1. Historic District Commission Virtual Meeting

HDC Work Permit Staff Review

Property address: 209 Washtenaw (formerly 127 N Washington)

Proposed work: Solar Array.

1 ROOF PLAN

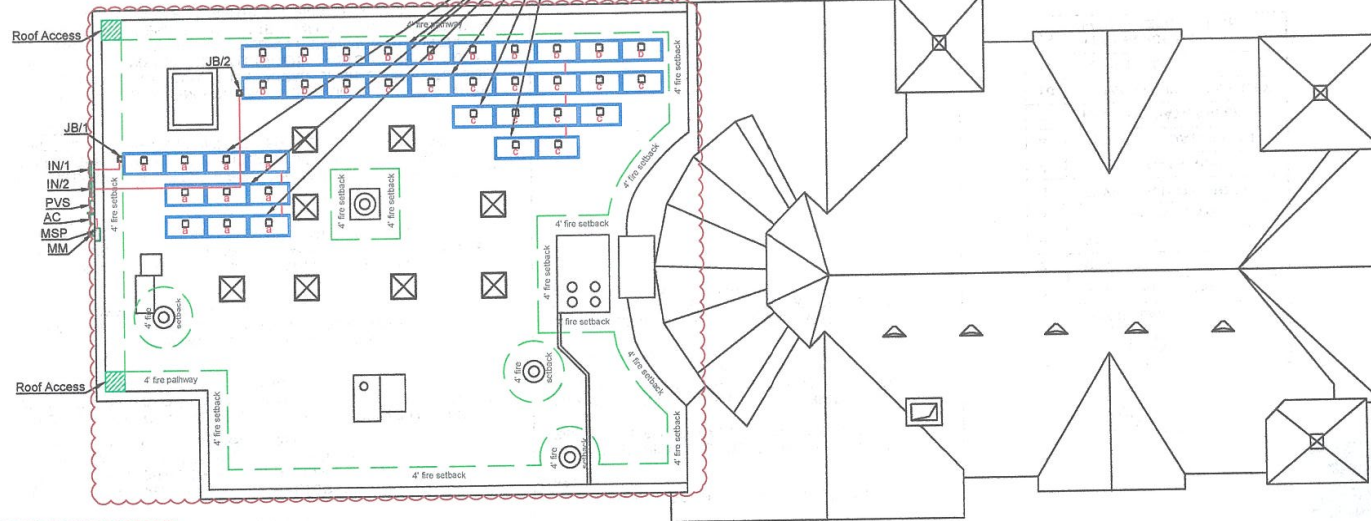
1. The applicant is proposing a 36-modular solar array on the flat roof of the education wing of the building.
 - a. The roof has a parapet on the north, west, and east sides.
2. The panels will be Hanwha 400W modules with a black cell and metallic frame.
3. The panels will be mounted using an iron ridge system, which attaches to concrete blocks. The roof will not need to be punctured as part of this installation.
4. A conduit for the inverter will extend down the west side of the building.

Move to approve and issue a Certificate of Appropriateness for the work at 209 Washtenaw as submitted in the application dated November 2, 2021, for installation of a solar array

system with 36 Hanwha 400 modules, as specified, with the connection boxes on the west elevation.
